BAP Precision Ltd.

Declaration of Product Modifications

This is to request a Class II permissive change for FCC ID: ZK7MSERIES, originally granted on 12/16/2015.

Product name: GPS Controller(GPS Receiver)

Change #1: Implementation in new platform

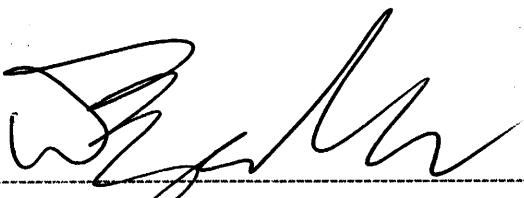
Change (1) This is to request a Class II permissive change for FCC ID: ZK7MSERIES, originally granted on 12/16/2015

Model number: S Series-A
